# **Descriptive Report to Accompany Hydrographic Survey H11124**

Project OPR-O112-TC-04 Deep Inlet Sitka, Alaska Scale 1:10,000 October 2004 **NOAA Time Charter R/V DAVIDSON** Lead Hydrographer: PS David A. Sinson, NOAA Survey Manager: Bonnie Johnston, NOAA

# **Revisions Compiled During Office Processing and Certification**

Figure 9. DTM of uncharted shoal with least depth of 9-fathoms shown in CARIS Subset Editor 3-D mode.

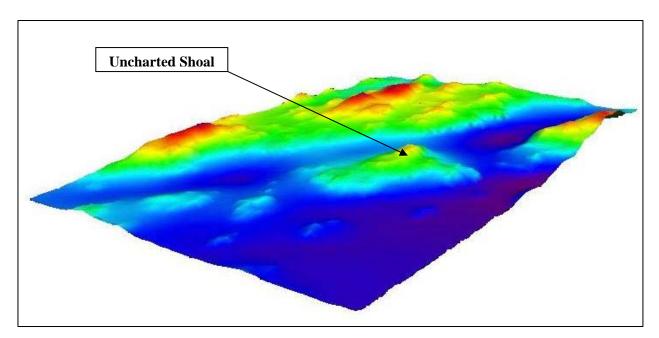
Within a 100-m radius of a charted 16-fathom sounding, the present survey revealed a depth of 9 fathoms at 56° 59' 52.62" N, 135° 18' 29.43" W. The 9-fathom sounding is the least depth of an uncharted shoal (Figure 9).<sup>13</sup>

<sup>13</sup> Concur.

Figure 10. Evidence of survey depths significantly deeper than charted depths.

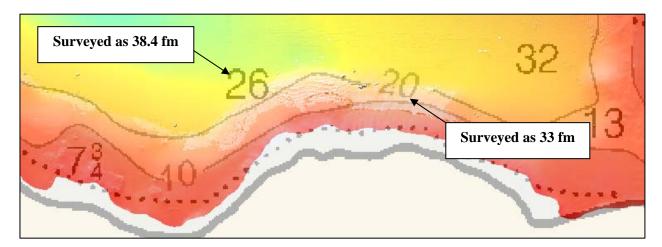
Survey depths were found to be significantly deeper than charted depths in the southeast region or "foot" of Deep Inlet, specifically along the 20-fathom contour line (Figure 10). A 33-fathom sounding was found in the vicinity of a 20-fathom charted sounding at  $56^{\circ} 57' 01.51'' \text{ N}$ ,  $135^{\circ} 13' 45.73'' \text{ W}$ . In the same proximity, a 38.4-fathom sounding was revealed over a charted depth of 26 fathoms at  $56^{\circ} 57' 01.28'' \text{ N}$ ,  $135^{\circ} 14' 04.71'' \text{ W}$ . Depth differences could be attributed to modern survey methods and steep slopes encountered along the borders of the bay.<sup>15</sup>

<sup>15</sup> Concur.

Figure 12. 3/4 – fathom shoal at the entrance to deep inlet (not fully developed).

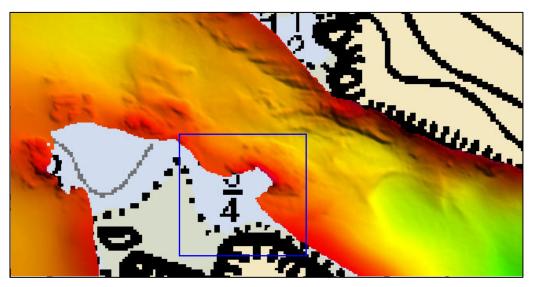
At the entrance to Deep Inlet, there is a charted <sup>3</sup>/<sub>4</sub> - fathom shoal.<sup>40</sup> Attempts were made for full development of the rock with SWMB, but 100% coverage was not obtained due to rough seas and strong currents. The rock blocks the southern approach to the inlet and its boundaries were defined with multibeam data (Figure 11). A least depth of 1.961 meters (1.07 fm) was recorded at 56° 59' 8.59" N, 135° 18' 21.17" W.<sup>41</sup>

<sup>40</sup> Strike "<del>shoal</del>". Insert "rock".

<sup>41</sup> Retain charted 3/4fm Rock and associated danger curve. Add danger curve to the ENC.
